Access Compliance Report

Public Rights-of-Way

Intersection ID: 27440	Main Street: BALLANTYNE_COMMONS_PY	Cross Street: DOWINGTON_DR	Location: SW
ADA ID: E92BE0E64045	Ramp Type: BlendTrans1	Initial Pass/Fail: Fail	Overall Compliance: No
		Severity Score: 17.5

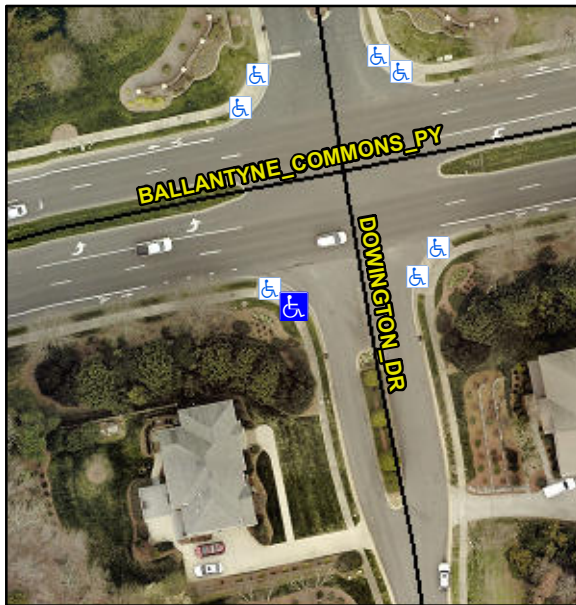
Not Found, R304.5.1

Compliance	Description	Data	Compliance	Description	Data
N/A	Ramp Length (in)	108.0	Yes	BlendTrans Slope (%)	3.8
No	Ramp Width (in)	32.0	Yes	BlendTrans XSlope (%)	1.5
N/A	Flare Type LT	N/A	N/A	Flare Type RT	N/A
N/A	Flare Slope LT (%)	N/A	N/A	Flare Slope RT (%)	N/A
N/A	Flare Traversable LT?	N/A	N/A	Flare Traversable RT?	N/A
N/A	Landing Length (in)	N/A	N/A	DWS Provided?	N/A
N/A	Landing Width (in)	N/A	N/A	DWS Contrast?	N/A
N/A	Landing Slope (%)	N/A	N/A	DWS Length (in)	N/A
N/A	Landing X Slope (%)	N/A	N/A	DWS Full Width?	N/A
N/A	Landing Curb? (Y/N)	N/A	N/A	DWS Offset (in)	N/A
N/A	Shared Landing?	N/A			
N/A	Gutter Ponding?	N/A	N/A	Gutter Slope (%)	N/A
N/A	Gutter Lip Ht (in)	N/A	N/A	Gutter X Slope (%)	N/A
N/A	Painted X Walk1?	No	N/A	Painted X Walk2?	N/A
	X Walk 1 Direction	To E		X Walk 2 Direction	N/A
	X Walk 1 Width (in)	N/A		X Walk 2 Width (in)	N/A
	X Walk 1 Slope (%)	2.2		X Walk 2 Slope (%)	N/A
	X Walk 1 X Slope (%)	2.3		X Walk 2 X Slope (%)	N/A

N/A	Ramp inside XWalk1?	N/A	N/A	Ramp inside XWalk2?	N/A
	Road Slope (%)	2.3		Clear Space?	N/A
	Road X Slope (%)	2.2	N/A	Clear Space to XWalk (in)	N/A
N/A	Any Obstructions?	N/A	N/A	Storm Grate/Utility Hazard?	N/A
	Obstruction Type			Storm Grate/Utility Type	
		N/A			N/A
			Yes	Surface Condition? (G/P)	Good
			No	Curb Slope (%)	23.1

Remove & Replace Curb Ramp With Two New Directional Ramps or Equivalent.
